**City of Kingston
Committee of Adjustment
Meeting Number 01-2022
Addendum**

k) Subject: Supplementary Report (to Report Number COA-22-013)

**City of Kingston
Report to Committee of Adjustment
Report Number COA-22-017**

**Re: Application for Consent to Sever New Lot
File Number: D10-034-2021
Address: 3028 Princess Street**

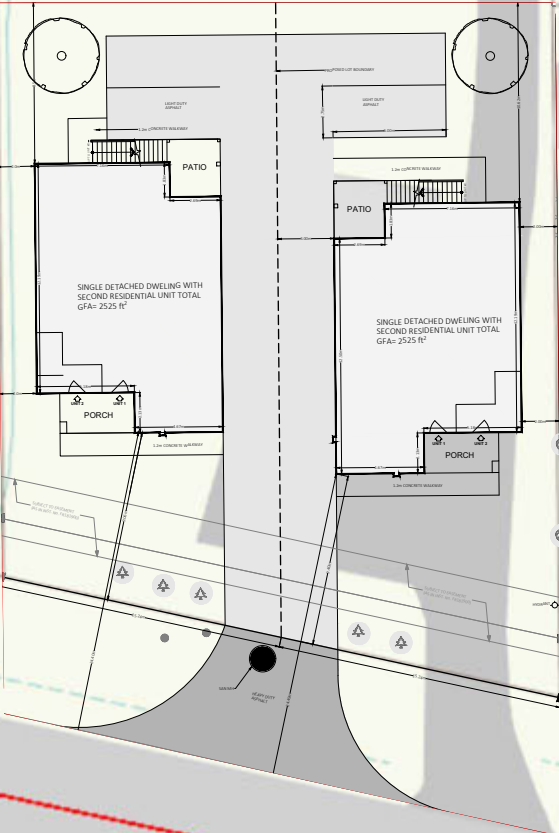
Finally, it cannot be imagined why the City would view this as a site for residential intensification by Consent. From a review of kmaps (attached to this document) there are no other lots along Outer Princess St. with a 50 ft frontage. This would set a new precedent. And if future developers would request similar lot frontages it would seem perfectly within their rights to do so, once a precedent is set. Thus it would turn Outer Princess St. into a subdivision road with driveways, accessing it, every 50 ft. One must ask if this is the vision for Outer Princess St. No other newer arterial road, including Bayridge Drive, Centennial Drive, or even older ones like Collin Bay Road allows residential access directly to the road. The case of Outer Princess St. is unique and historical and it is unlikely in the interests of the City to promote further direct residential access, mainly due to the impact on traffic flow and as a traffic safety issue. In fact, this very issue is referenced in 9.6.13 Criteria for Consent Approval of the Official Plan which states as one of the criteria for approval that "***d. direct access from major roads is limited...***". Princess St. is one of the major roads in Kingston. It was the former King's Highway No.2. Princess St is a Gateway to the City, as well as, an Emergency Detour Route for the 401 in this location. Councilor Osanic in one council meeting this year, with regard to turtle fencing, a short distance west of this site, stated that 10,000 cars use this road every day.
